Re: ABQ Farms TI- 912 Eubank Blvd NE
Traffic Circulation Layout
Architects Stamp 2-19-24, Revision 6-25-24 (J21D046)

The TCL submittal received 6-25-24 is approved for Building Permit by Transportation. A copy of the stamped and signed plan will be needed for each of the building permit plans. Please keep the original to be used for certification of the site for final C.O. for Transportation.

STREET SIGN ELEVATION EXHIBIT
1/8" = 1'-0"

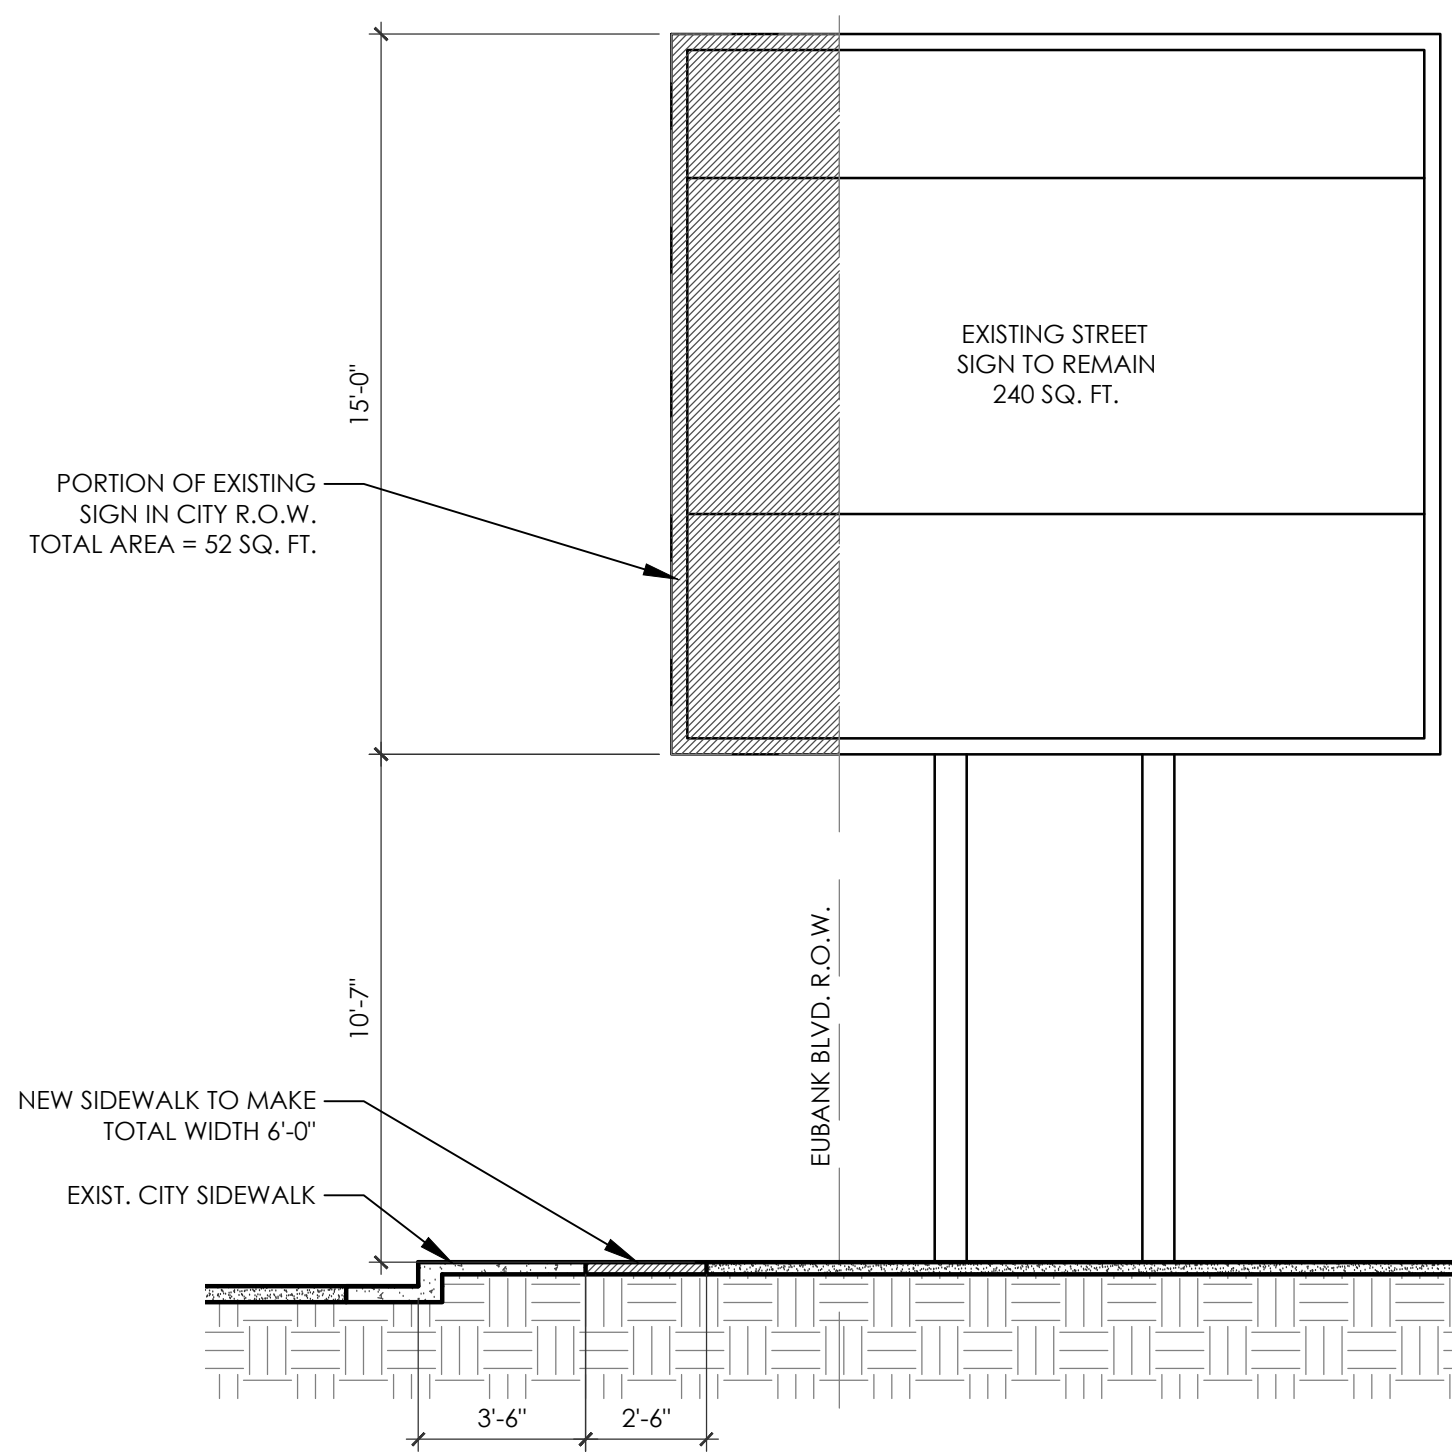
A recorded Revocable Permit for the monument sign is required as a condition of Certificate of Occupancy.
